Comments on Draft Report Dynegy Midwest Generation- Vermilion Power Station

**RE: Draft Coal Combustion Waste Impoundment Round 6 - Dam Assessment  
Report Dynegy Midwest Generation, Inc. Vermilion Power Station Fly Ash  
Dikes (Site 015), dated September 2009**

**DMG Comments**

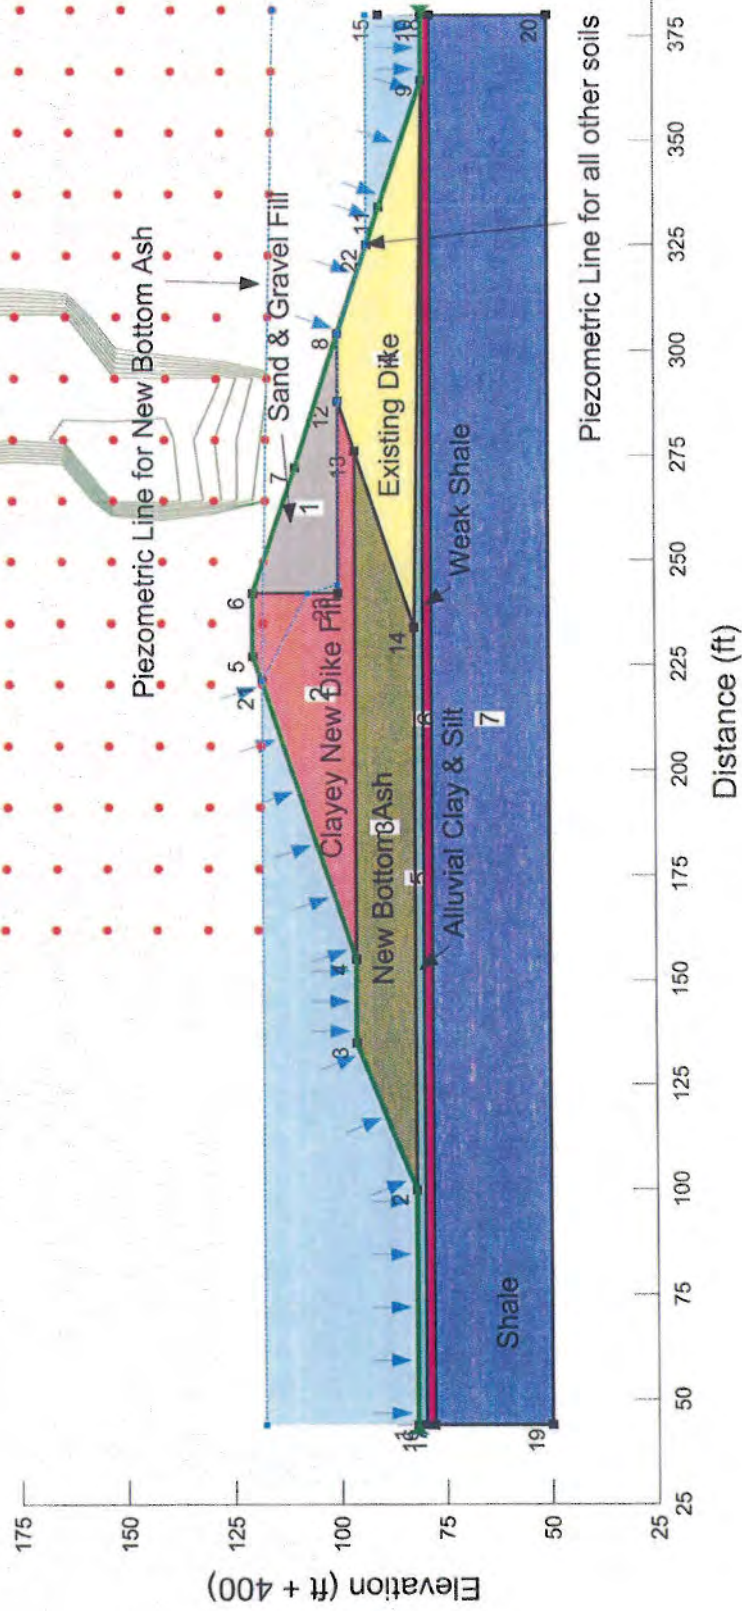
- 1. The analyses evaluated only long-term stability using long-term, drained soil strength data. A short-term, post construction event can produce short-term increases in soil pore pressure and a corresponding decrease in shear strength. This phenomenon can cause failure of embankments that have otherwise been stable for decades.*

Drained soil properties were originally used because they resulted in lower factors of safety. URS re-ran the rapid drawdown and seismic loading cases using the undrained shear strength values provided in the original calculations for Critical Section 2, which is enclosed for your review. Section 2 controlled the design due to the lowest factor of safety for these cases. The results show that the factor of safety is increased when undrained soil properties are used. The results are presented as follows:

Case	Original (Drained Soil Properties) Factor of Safety	Revised (Undrained Soil Properties) Factor of Safety
2A: Downstream Slope, Full Pond, Seismic and Gravity Loads	1.4	2.0
2B: Upstream Slope, Full Pond, Seismic and Gravity Loads	1.2	1.2
3: Upstream Slope, 20 ft rapid drawdown, Gravity Loads Only	1.3	1.4
